This gallery shows some pictures of bad solderings - they should prevent you from making the same errors (feel free to add even more pictures here!)

From:
<http://www.midibox.org/dokuwiki/> - **MIDIbox**

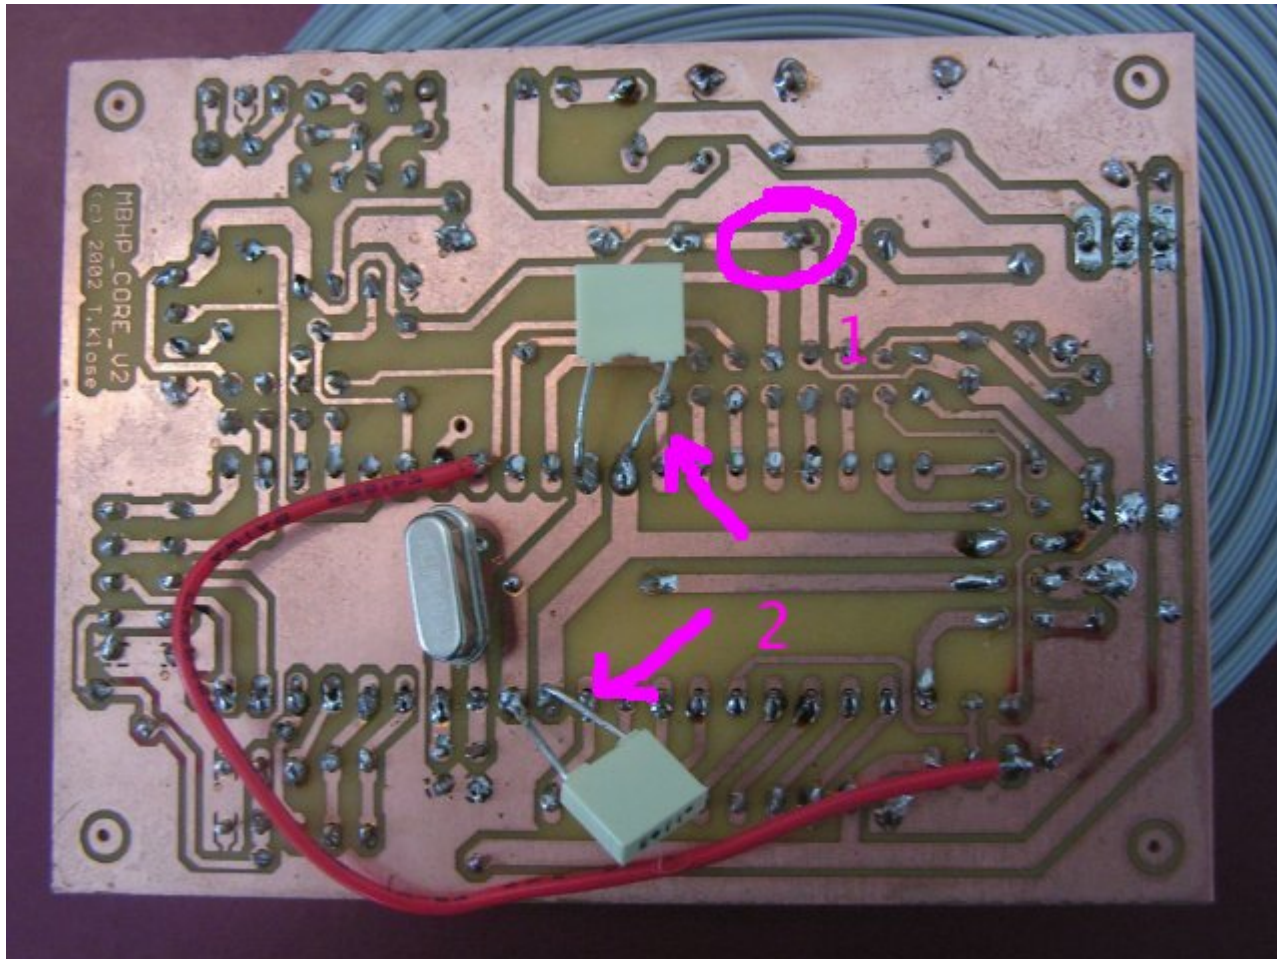
1: the core module has some bad solderings (loose connections), which could lead to failures. There are also missing solderings (e.g. 33pF cap below crystal). It makes sense to solder each pad again, the [Soldering](#) guide in the Wiki gives some useful tips

2: the legs of the caps should be cutted, otherwise they can cause a short circuit which can damage the PIC!

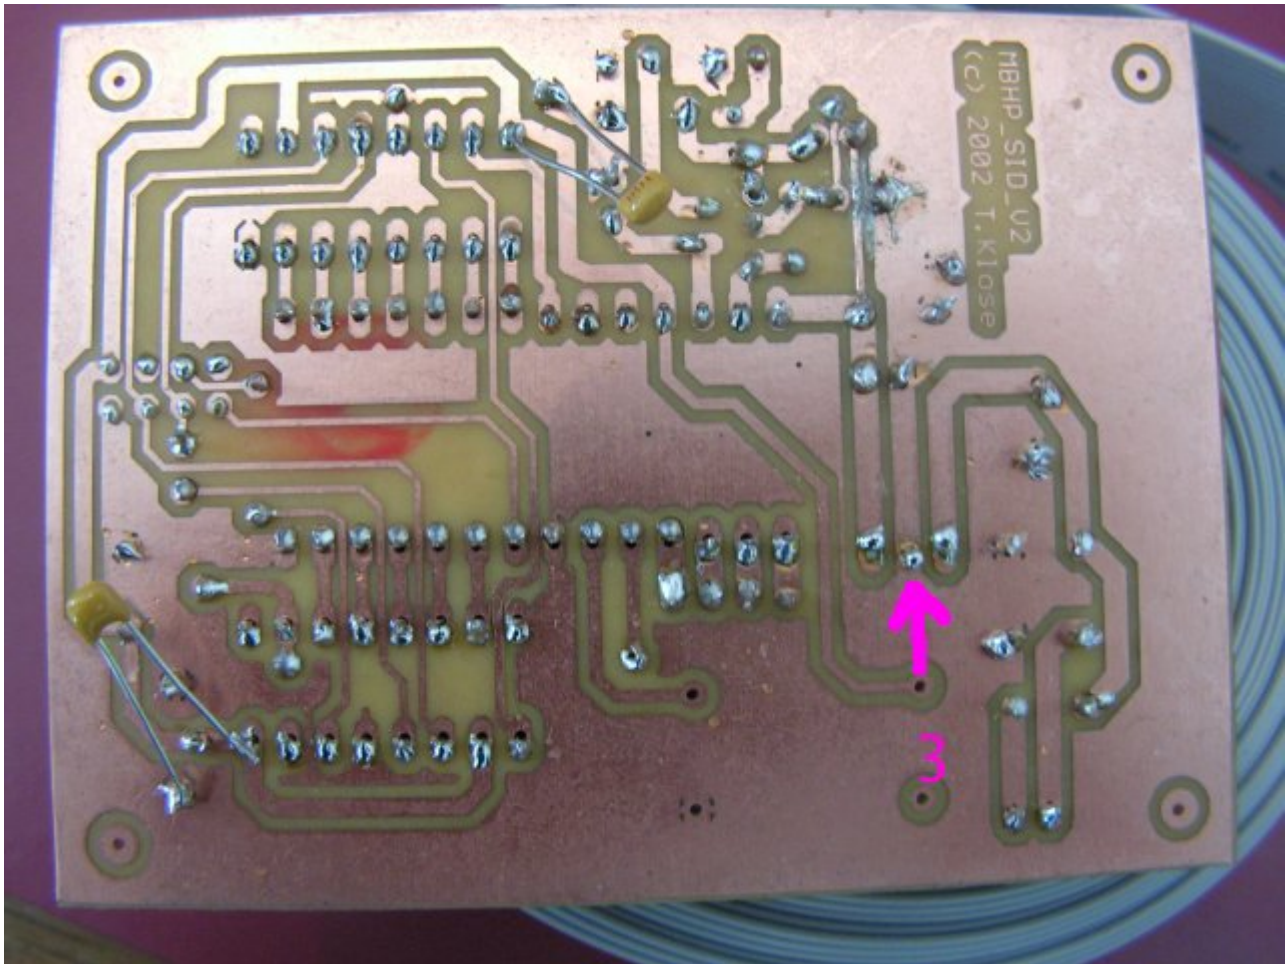
3: this seems to be a bad ground connection directly at the 78xx - it can lead to the wrong voltage. Here the same: just solder the pads again, it will help
And same like above: the long cap legs need to be cutted, the danger for shorts is too high!
